**SUBSIDENCE IMPACT ASSESSMENT  
– GUJARAT NRE NO. 1 MAJOR EXPANSION  
PROJECT  
Independent Peer Review**

**PART 3: Review of NRE Preferred Project Report –  
Subsidence Assessment**

**REPORT NO:** 1303/02.3

Figure 2: Plan showing the design constraints (lease, geological, mining, and surface protection) as the basis for the PPR mine layout design

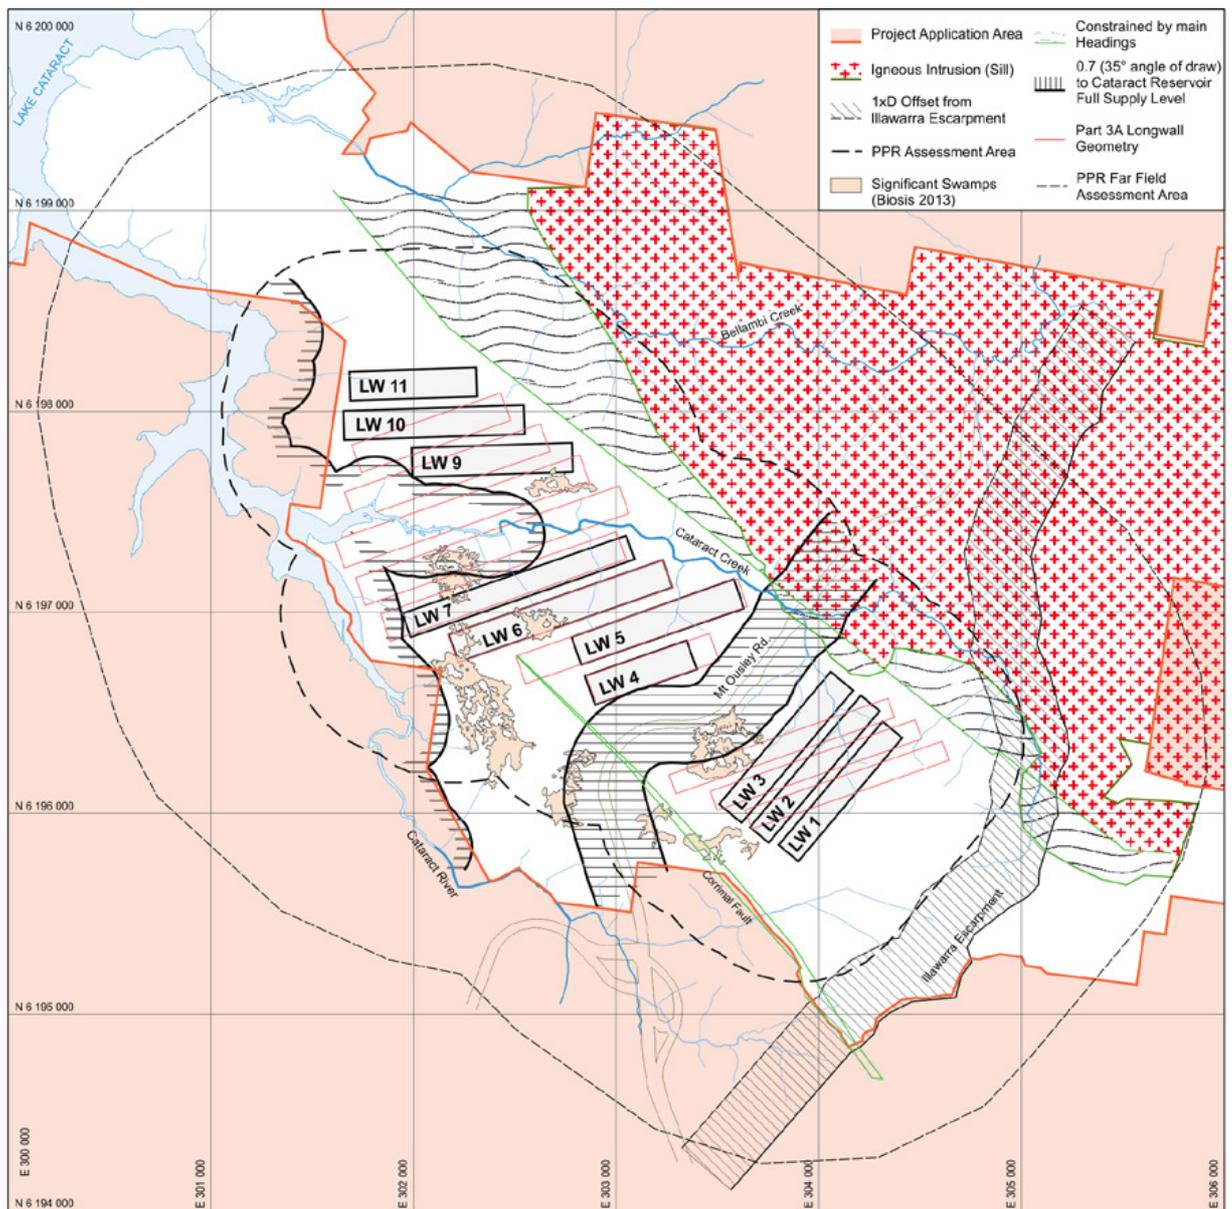
- 1) Section 2, p4 – This includes a useful summary of the subsidence constraints used in the redesign of the mine plan for the PPR. This is reproduced below:
  - *The constraints of the mine lease.*
  - *Geological constraints including the Corrimal Fault in the south, silling (an igneous intrusion within the seam) in the north, and coal quality considerations and its impact on mining height.*
  - *Mining constraints associated with the need for main headings in the north and the legacy of previous mining extent and geometry.*
  - *Surface subsidence constraints including:*
    - *Avoiding longwall extraction within 0.7 times depth (equivalent of 35° angle of draw) of the full supply level (FSL) of Cataract Reservoir including the section of the reservoir that extends up Cataract Creek.*
    - *Avoiding mining directly under the third and fourth order sections of Cataract Creek.*

- Minimising impacts on Mount Ousley Road to tolerable levels by remaining beyond approximately half depth (equivalent to 26.5° angle of draw) from the road easement.
- Significant upland swamps.

These constraints all seem reasonable and appropriate, however the constraint with respect to the significant upland swamps lacks any quantitative or measurable definition, in terms of how does this translate to a design constraint. Figure 2 is a copy of Figure 2 from the SCT report, showing both original and the revised PPR mine layouts, together with the various constraints identified above.

Figure 3. Superimposed mine workings (all three seams)  
 (source: SCT Report NRE14123)

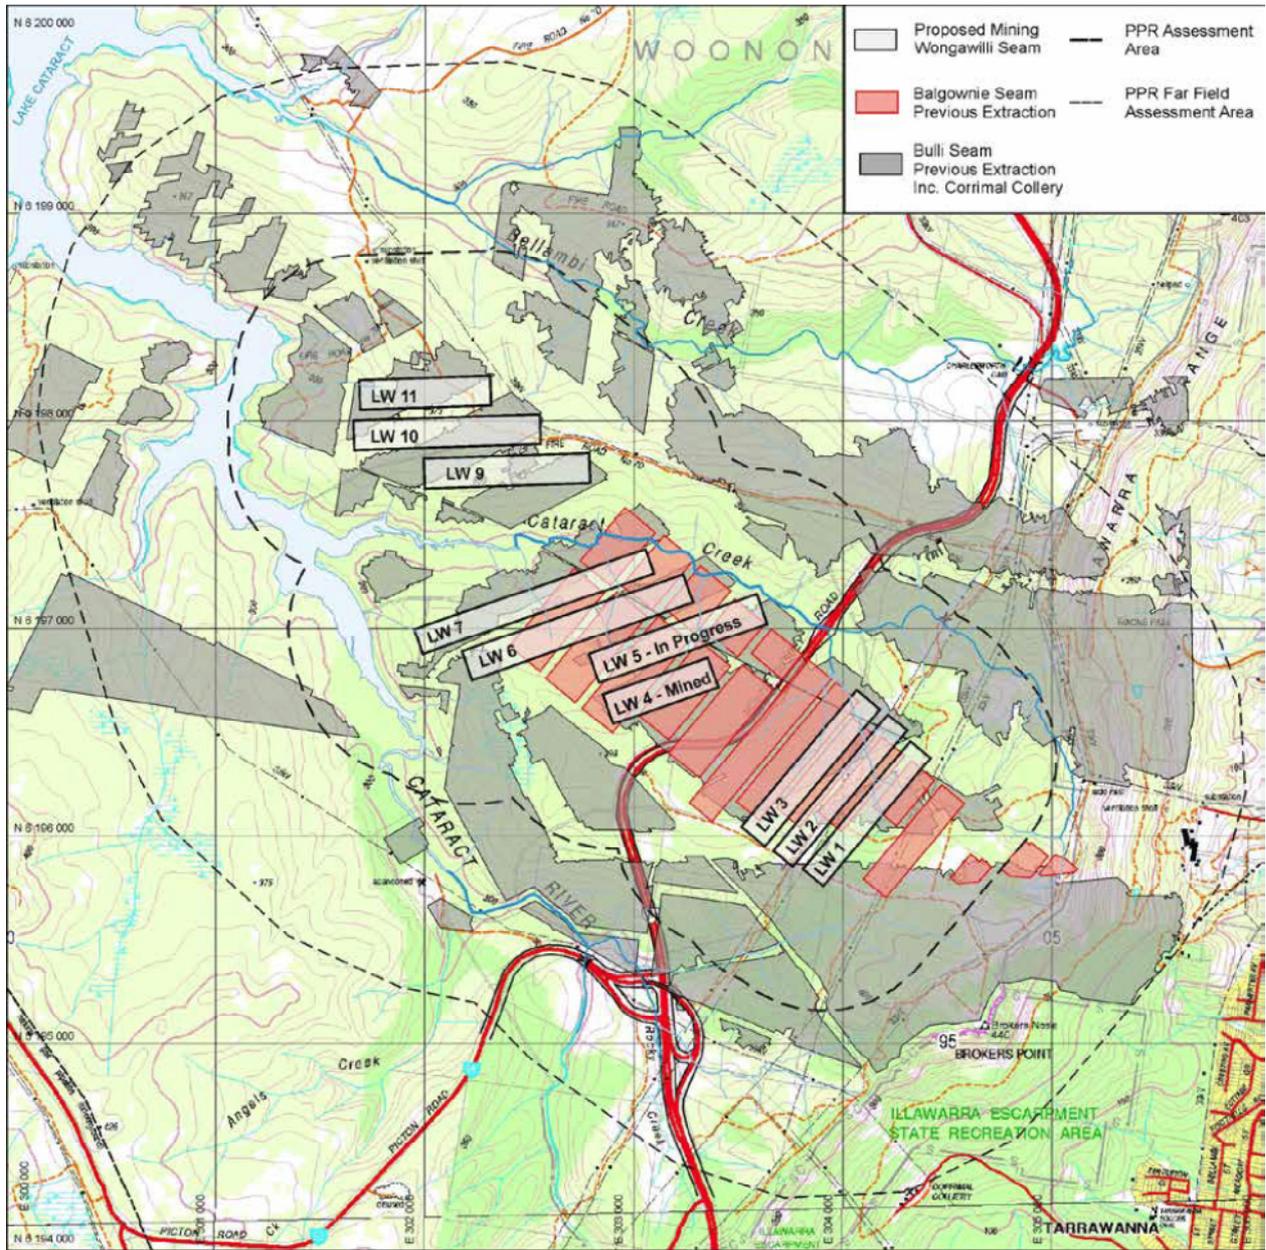
- 2) Figure 3 provides a good overlay of the proposed Wongawilli longwall panels, together with the location of the previous Balgownie Seam longwalls and the areas of old Bulli Seam bord and pillar workings. This is reproduced from Figure 11 of the SCT report.

- 4) Section 3, p20 notes that an extensive underground inspection was undertaken on 21 June 2013 which has identified an area of pillar workings in the Bulli Seam above/adjacent to the proposed Wongawilli panels which are likely to be destabilised as a result of Wongawilli undermining. (This is backed up by evidence of pillar destabilisation caused by the previous Balgownie longwalls, in a similar area of Bulli Seam pillar workings). It is noted that such effects are likely to be localised, and confined close to the new goaf edge, but need to be taken

into consideration. This has already been discussed under section A(4), and relates to an area near Longwall 1 (further discussed on SCT Report p23).
